INDESIT company

Model type:
AVSD127EX

Commercial code:
F029770

General notes

n1040325: New shock absorber fixing system with pin

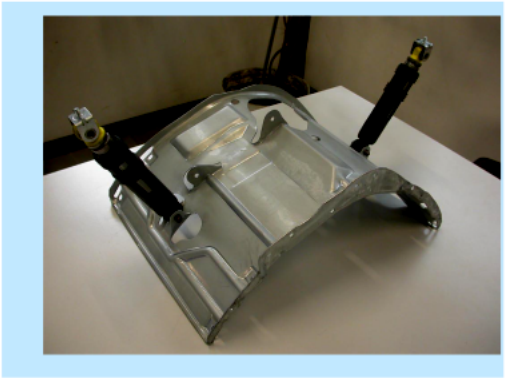
From serial no. 40427.0001, shock absorbers have been fixed to the tank unit cradle with two 11 mm pins code C00110163 (see fig. 01 and 02 enclosed) in place of the 8 mm screws code 093750 and relevant locking nuts code 030443, on all washing

machines and dryers produced in the Comunanza factory.
The items affected by this modification are:
1) The cradles have the same Service code, as they can be used in place of the new ones after widening the shock absorber fixing holes to a diameter of 10 mm.
Code 093848 - Tank unit cradle 46 lt
Code 093878 - Tank unit cradle 40 lt.
2) The new shock absorbers, with fixing bushing having no s/steel spacer, are not managed as they are interchangeable with the premodified items (make sure they are CIMA type, as the managed items), fixed with M8 screws code 093750 and related locking nut code 030443 (see figs. 05 and 06).
Code 093884 - Shock absorber 80 N
Code 093885 - Shock absorber 100 N

To remove the shock absorber from the tank, first extract the pin with a few hammer taps (see fig.03) until it is aligned with the tank bracket and then pull it out with a pair of pliers (see fig. 04).
(To refit the shock absorber use a new pin. Insert the pin until the toroidal edge is aligned with the bracket.)

n1040326: Two-bearing mechanism on Slim range washing machines

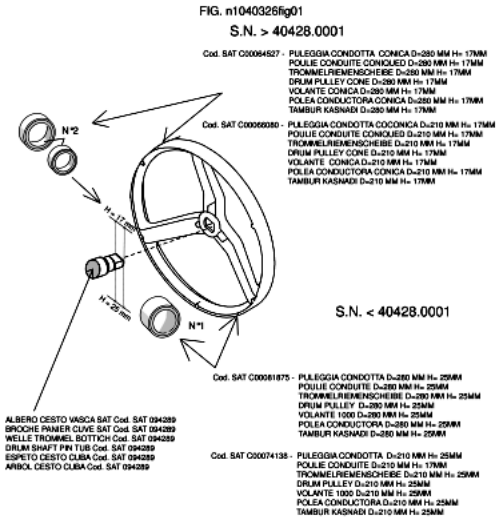
From serial no. 40428.0001, all Slim range models produced in the Comunanza factory have been equipped with a two-bearing mechanism in place of the single-bearing one.

The Service codes of the new mechanism are:
Service code C00096186 - SEAL RING CV4;
Service code C00002591 - BEARING 20X47X14 6204 SKF;
Service code C00013563 - BEARING 25 X52 X 15 6205 - 2Z SKF;
Service code C00110340 - CROSS WITH SEAL RING (2C) SNELLA;
Service code C00094289 - EVO 40L TANK SLIM (1-C) > (2-C)EVOII;
Service code C00094290 - OUTER- SET 40 L.(1-C)>(2-C)EVOII;
Service code C00064527 - DRIVEN PULLEY CONE D=280 MM H= 17MM;
Service code C00066080 - DRIVEN PULLEY CONE D= 210 MM H=17 MM.

The tank assembly with the new two-bearing cross has the same Service code as the single-bearing one (C00094289); the latter will be available until stocks run out.
When replacing the tank, make sure that the value H (17 mm or 25 mm) of the basket cross shaft corresponds to the value H of the pulley (see Fig.001).

The following premodified items will continue to be used:
Service code C00026298 - BEARING BA2B 633667 30X60.03X37;
Service code C00039667 - SEAL RING;
Service code C00074137 - CROSS WITH SEAL RING;
Service code C00081875 - DRIVEN PULLEY D=280MM H=25MM;
Service code C00074138 - DRIVEN PULLEY D = 210MM H=25MM;
Service code C00026299 - SEEGER RING SB 60X1,5.

Fig . 001

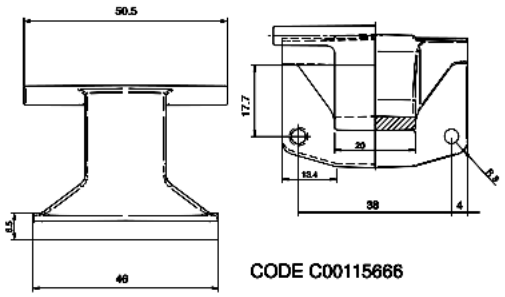
From serial no. 50207.0001, all Ariston models produced in the Comunanza factory (see table 001 attached) with industrial code (given on the rating plate) starting with 80, have been equipped with a Zamac hinge with 150° opening angle, code C00115666 (see Fig.001).
This modification has involved the introduction of the following items:

Code C00115670 - Complete door EVOII 150° white 27 with standard glass;
Code C00115674 - Complete door EVOII 150° white 27 with long glass;
Code C00115668 - Complete door EVOII 150° silver with standard glass;
Code C00115673 - Complete door EVOII 150° silver snella standard glass;
Code C00115662 - EVOII body for 150° hinge white 27
Code C00115663 - EVOII body for 150° hinge silver 27
Code C00115664 - Snella EVOII body for 150° hinge white 27
Code C00115665 - Snella EVOII body for 150° hinge silver

The premodified items are not interchangeable separately with the modified ones.

Code C00096416 - Complete door EVOII LB 180° standard depth silver;
Code C00097374 - Complete door EVOII 180° WD 180° white 27 long glass;
Code C00110133 - Complete door EVOII Standard 180° white 27
Code C00110178 - Complete door EVOII Snella 180° Silver;
Code C00091836 - EVOII body white 27 for 180° hinge;
Code C00094306 - EVOII body silver for 180° hinge;
Code C00094305 - Snella EVOII body white 27 for 180° hinge;
Code C00094307 - Snella EVOII body silver for 180° hinge;

Fig . 001

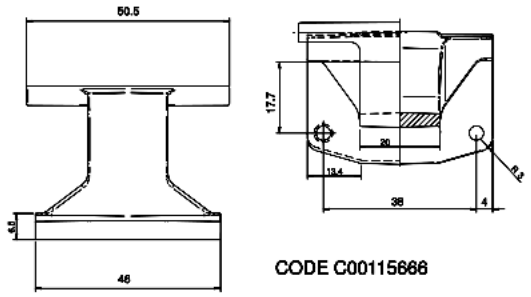
From serial no. 50315.0001, the new "Polar White" colour is used on all washing machines and washer-dryers produced in factory 80 in place of White 27.
The third last number of the Industrial Code given on the rating plate of the modified models is 9 (e.g. 80286390900).

To determine the new Polar White codes, it is necessary to know the industrial code or serial number of the appliance being repaired.
The new items, which bear the initials "PW" in place of "B27", are not aesthetically interchangeable with premodification items as the whites are different. Both colours will be available for some time.
The items affected by this modification are:
Body, rear panel, top, control panel, handles, buttons, knobs, knob disc, door and plinth.
